WCAP-14756-A
Project Number 686

Subject: Westinghouse Owners Group
Transmittal of Approved Version of WOG Aging Management Report,
"Aging Management Evaluation for Pressurized Water Reactor
Containment Structure," WCAP-14756-A (MUHP-6110)

Aging Management Evaluation for Pressurized Water Reactor Containment Structure

Figure 2-2 Type 2 Containment Cross-Section

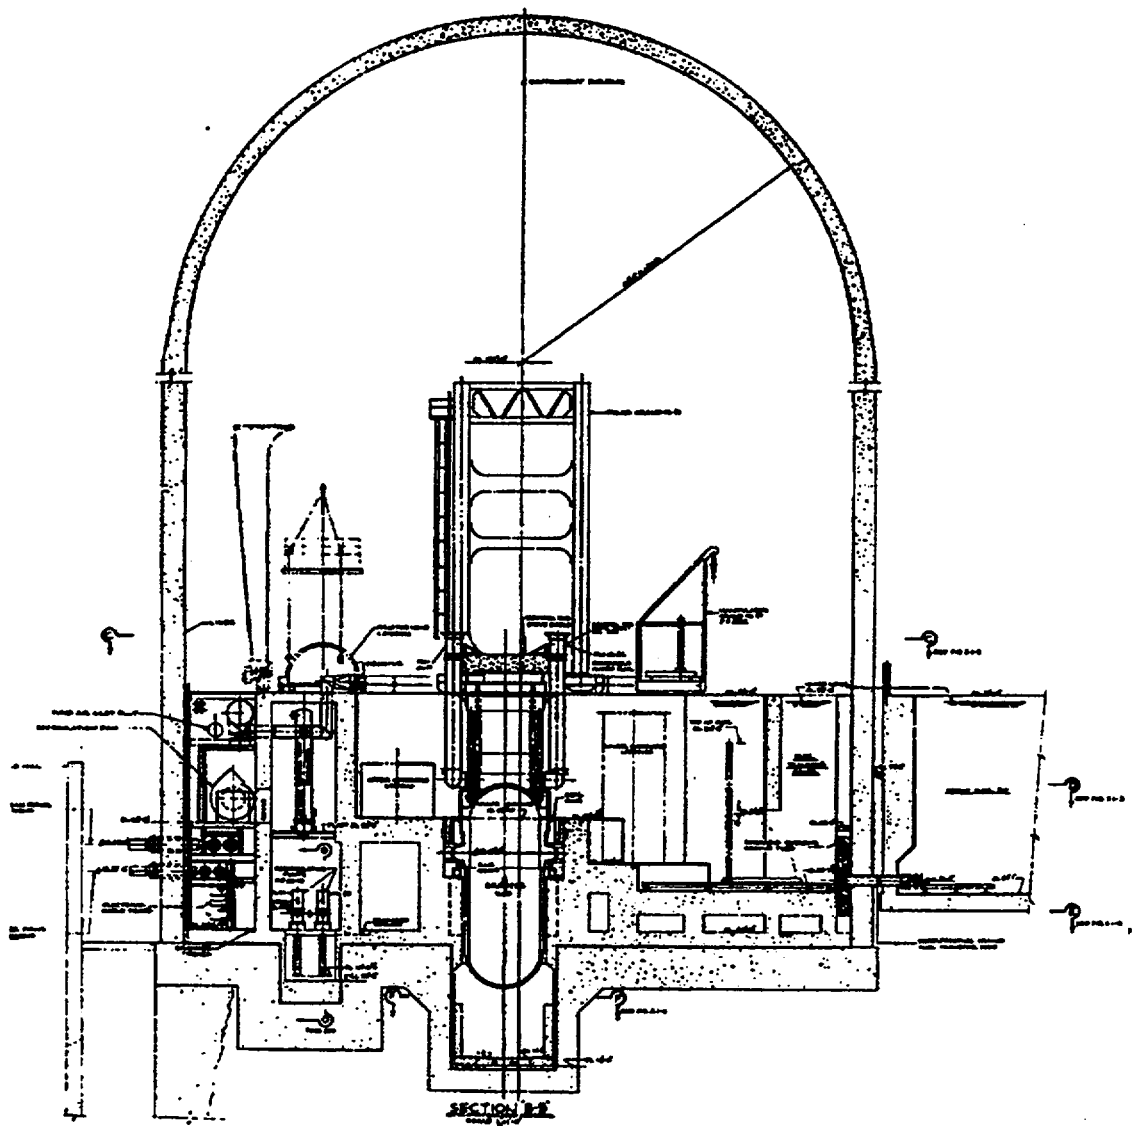
Since many of the sketches of equipment details presented in the GTR are not legible (e.g., Figures 2-2, 2-7, 2-10 and 2-13), the staff requested in RAI No. 32 (NRC letter dated February 19, 1998) that clear and legible figures be provided. In response (letter dated May 29, 1998), WOG indicated that the sketches in the GTR provide overall general characteristics of the different configurations and types, and do not provide details to the level requested in the RAI. WOG indicated that the requested details would be provided as needed as part of the license renewal application. This issue is designated as Renewal Applicant Action Item No. 5.

5. Provide legible drawings of equipment and penetration details as part of the description of the containment structure components.
6. For prestressed concrete containments, indicate whether the tendon access gallery is included as a containment structure component subject to an aging management review. If it is, provide the details of the aging management review and the credited aging management program. If not, provide a technical basis for its exclusion, addressing the potential for degradation of the lower vertical tendon anchors resulting from the environmental conditions in the tendon access gallery.
